**TEXAS UTILITIES GENERATING CO.
COMANCHE PEAK S. E. S.**

**ANALYSIS OF THE CLOGGING OF ECCS
SUMP TRASH RACKS BY DEBRIS AND
PAINT PEELS FOLLOWING AN ACCIDENT**

ERRATA
FOR EBASCO REPORTS
June 1, 1984

Figure 6

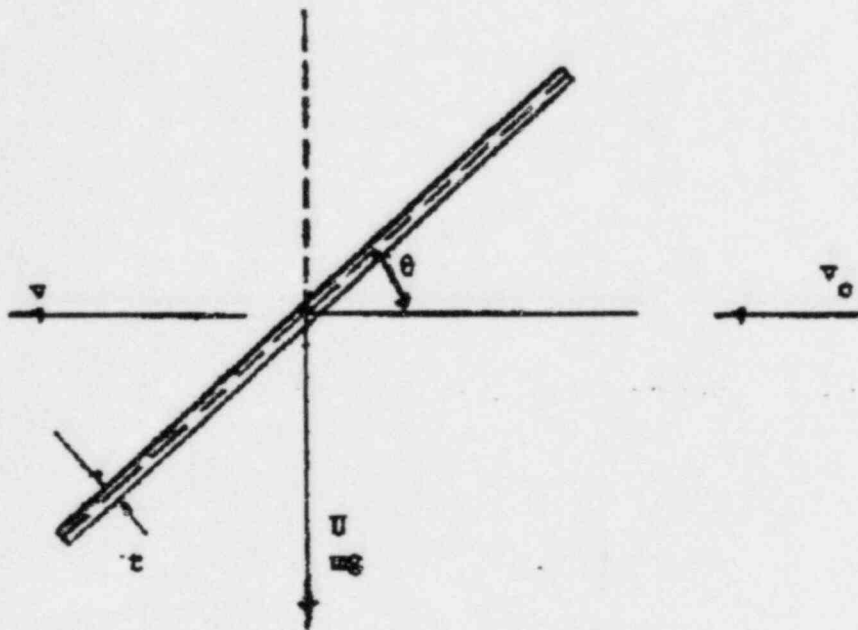
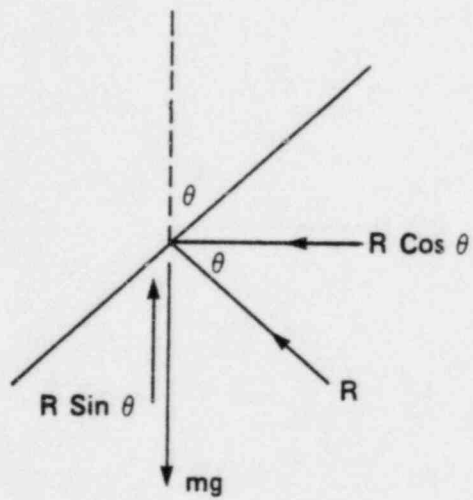
Figure 6 illustrates a paint peel at an angle θ to the horizontal moving under water. The weight mg acts vertically downwards. The peel would fall down under the influence of mg opposed by drag and aerofoil type of lift forces. The equations of motion in the vertical and horizontal directions respectively are:

$$m \frac{du}{dt} = mg - \frac{C_{Du}}{2} \rho_w A \cos^2 \theta U^2 \quad (1)$$

$$m \frac{dv}{dt} = \frac{C_{Lu}}{2} A \cos \theta U^2 - \frac{C_{Dv}}{2} \rho_w A \sin \theta (v - v_0) |v - v_0| \quad (2)$$
